Public Comment No. 126-NFPA 13-2020 [Global Input]

Do not revise the obstruction tables in Chapters 10, 11, 12, 13 & 14 (beam blocking rules) to eliminate dimensional ranges. Retain the dimensional ranges as they are in the current 2019 edition of NFPA 13.

Figure 10.2.7.2(d) Obstruction in Hallway.

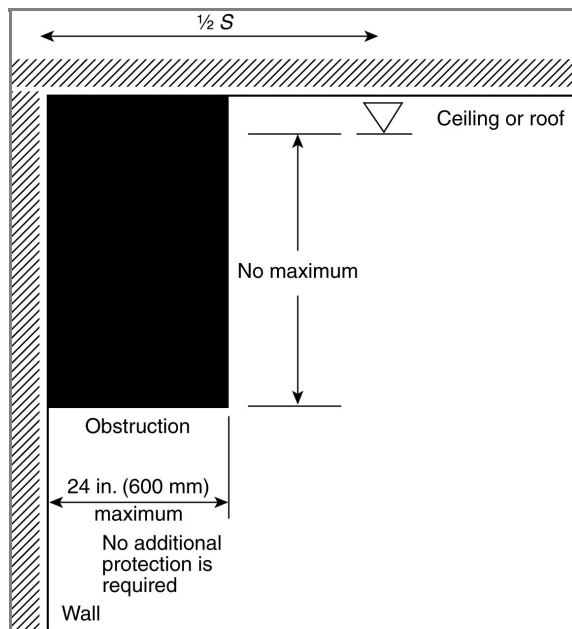
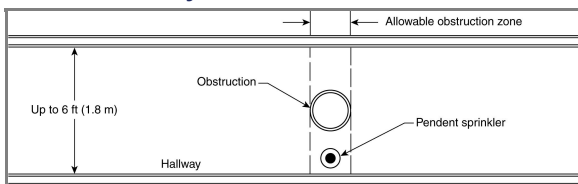
If the 1 ft wide obstruction is round, and located in the centre of the corridor, as shown in figure 10.2.7.2(d), with the sprinkler in the obstruction zone 4 inches away, the “shadow area” is approximately 17 ft² in size. Should the obstruction have a square shape, the obstructed floor space would be approximately 22 ft² in area.

The corridor obstruction allowance conflicts with other existing obstruction allowances which clearly would not allow such an obstruction. While the risk of fire and fuel load is low in a corridor, the fire suppression would be inhibited should this condition be applied to all sprinklers in a corridor. Especially concerning would be dead end corridors where the only path of egress could be compromised. This comment would apply to all similar occurrences.

- (5) Obstructions no greater than 12 in. (300 mm) in width in hallways up to 6 ft (1.8 m) in width shall be permitted in accordance with Figure 10.2.7.2(d) when the sprinkler is located within the allowable obstruction zone, zone and the closest edge of the obstruction is a minimum of 12 in. (300 mm) away from the deflector.

Figure 11.2.5.1.2(d) Obstruction in Hallway

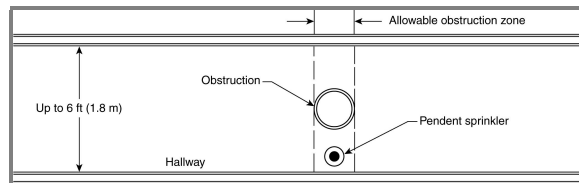
The substantiation from PI No.283 that that was accepted with this revision was “Adds another obstruction allowance for obstructions in hallways.” and “This is also found in NFPA 13D & NFPA 13R.”. This reasoning actually provides no technical justification at all for the matter.

If the 1 ft wide obstruction is round, and located in the centre of the corridor, as shown in figure 10.2.7.2(d), with the sprinkler in the obstruction zone 4 inches away, the “shadow area” is approximately 17 ft² in size. Should the obstruction have a square shape, the obstructed floor space would be approximately 22 ft² in area. Since the TC recently deleted part of the 3 Times Rule regarding vertical obstructions within 2 ft of a sprinkler and with the limitation of just a 15 ft², this new provision is much too liberal, and should be deleted.

- (5) Obstructions up to 12 in. (300 mm) in width in hallways up to 6 ft (1.8 m) in width shall be permitted in accordance with Figure 11.2.5.1.2(d) when the sprinkler is located in the allowable obstruction zone, zone and the closest edge of the obstruction is a minimum of 12 in. (300 mm) away from the deflector.

Figure 12.1.7.5(a) Maximum Distance Between Sprinklers with Sloped Ceilings — Arrangement A.

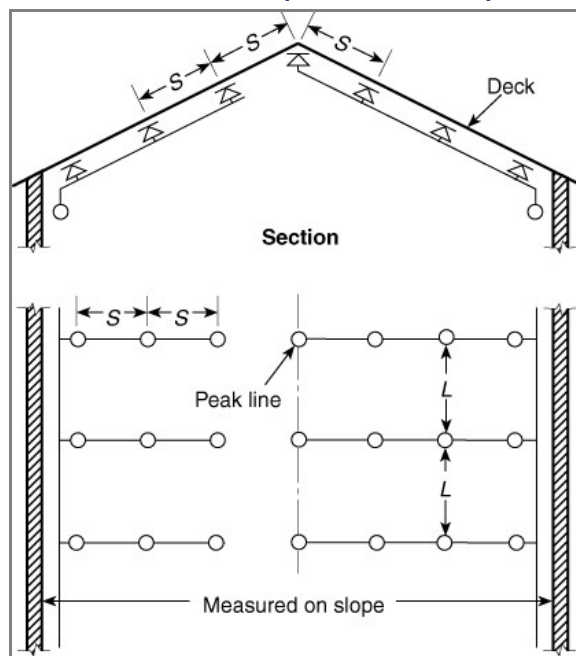
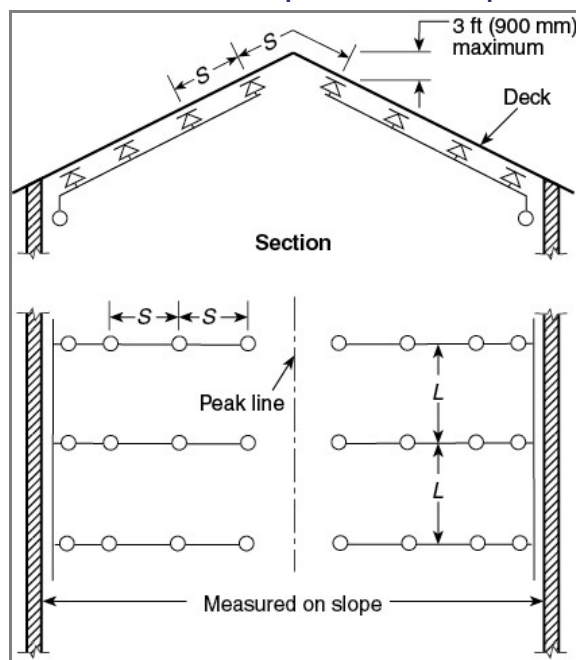
As noted by the correlating committee, the requirement for a sprinkler to be installed within 3 ft of the peak needed

Figure 12.1.7.6(a) Minimum Distance Between Sprinklers with Sloped Ceilings — Arrangement A.

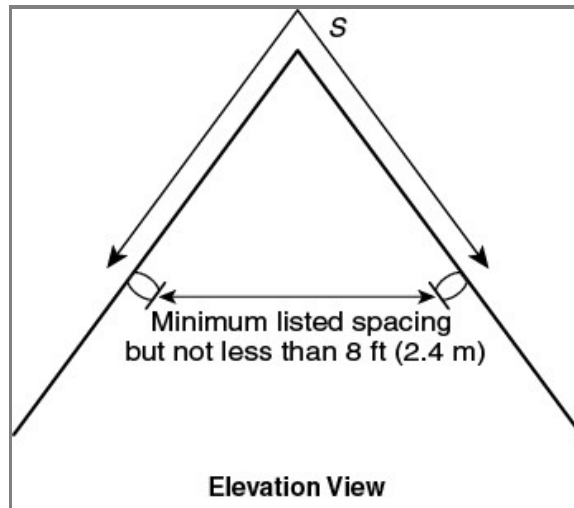
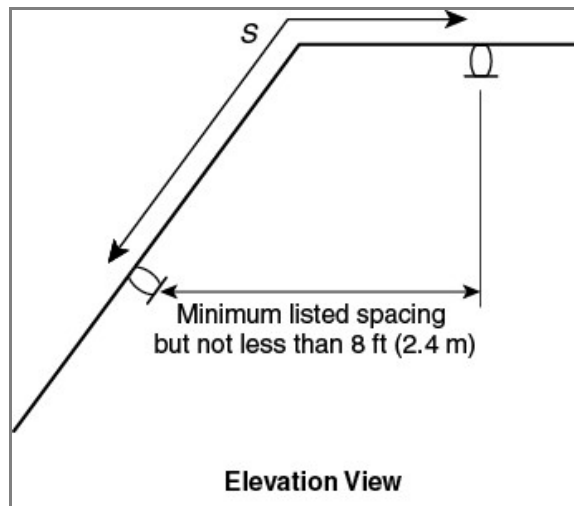
Statement: The existing Figure 12.1.7.6(a) was deleted and replaced with a new figure that depicts a more common installation while showing the sprinkler within 36". The new figure is being added to correlate with NFPA 13D/13R.

Figure 12.1.8.1.2(a) Position of Sprinkler Under Beam.

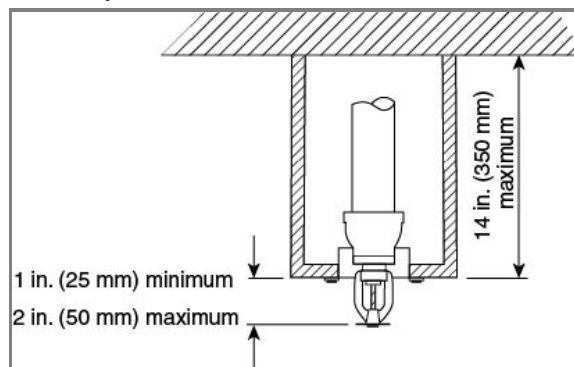
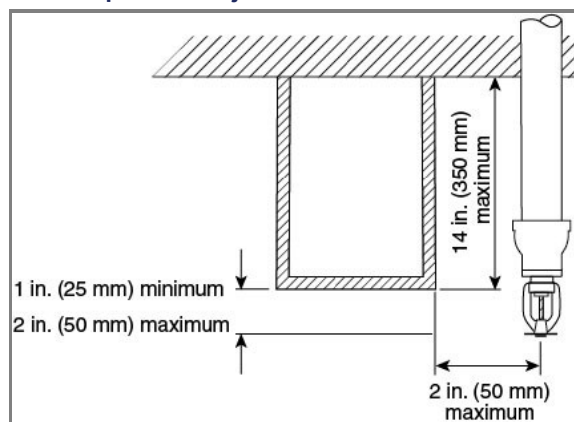
It is not appropriate to bury a concealed sprinkler in a beam as proposed. Concealed sprinklers are listed as assemblies that include vented escutcheons, so that hot gases from a fire will pass through, past the sprinkler linkage, and up into the ceiling space. If the sprinklers are buried in a beam (either solid or hollow), the listing of the sprinklers will be violated because they will be installed in a closed/unvented space, and the sprinkler will most likely not activate until the fire gets very large and the hot gases entirely fill the space between the beams in order for enough heat to activate the sprinklers.

Figure A.9.1.1(3)(b) Example of Shadow Area.

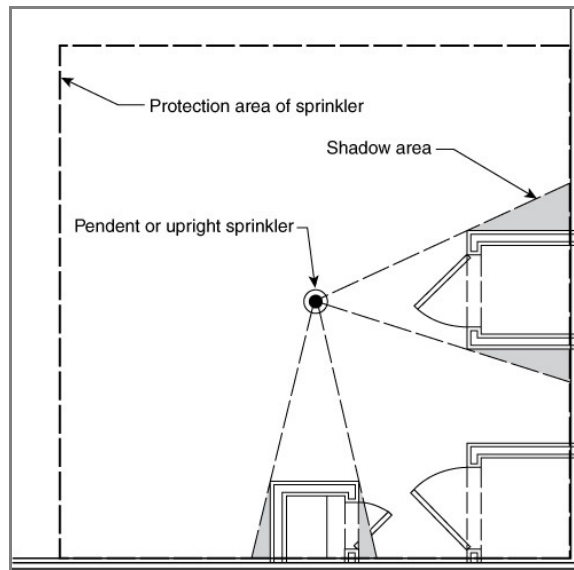
Correction of an editorial reference. The obstruction rules are now in Chapters 9 through 14.

Figure A.11.3.6.1.6 Permitted Obstruction on Wall Opposite EC Sidewall Sprinkler.**Statement of Problem and Substantiation for Public Comment**

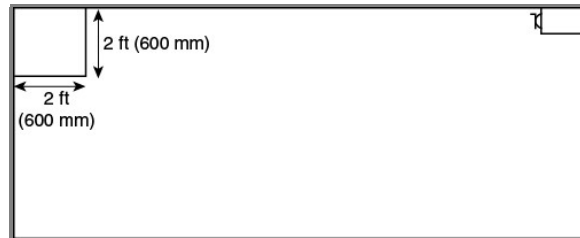
See Public Comment 129 for reason for deleting this section.

Figure A.12.1.11.1.6 Permitted Obstruction on Wall Opposite Residential Sidewall Sprinkler.**Statement of Problem and Substantiation for Public Comment**

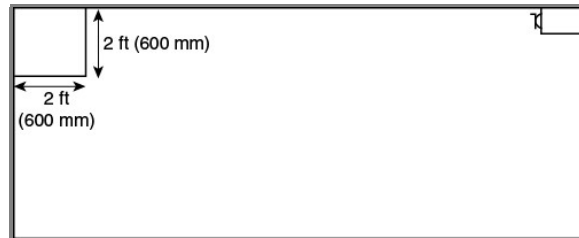
See Public Comment #131 for reason for deleting this section.

Figure A.15.3.1(e) Dry Sidewall Sprinkler Through Wall.

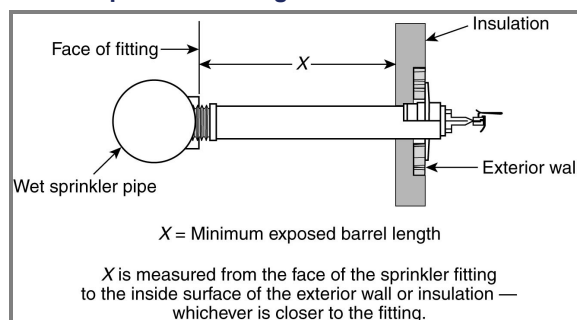
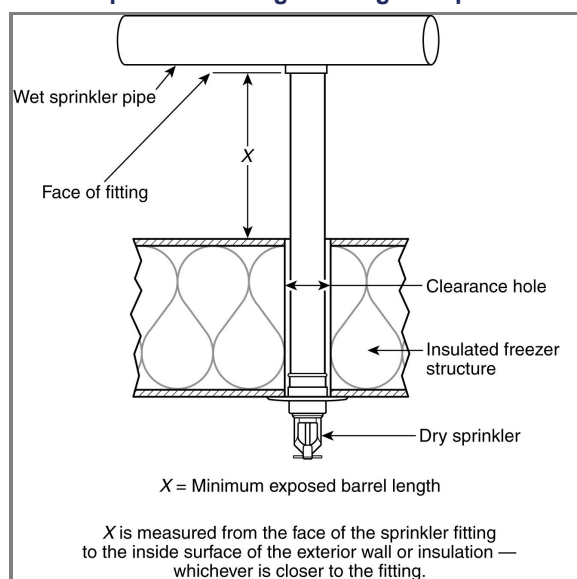
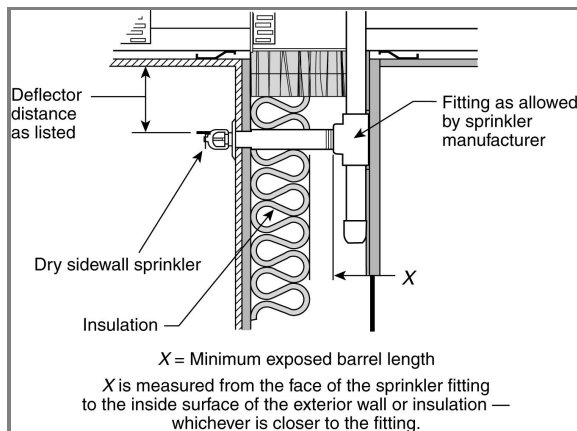
The note in figure (e) about the fitting needs to be added to figures (a) and (b). This is a common mistake and adding the note might prevent an issue.
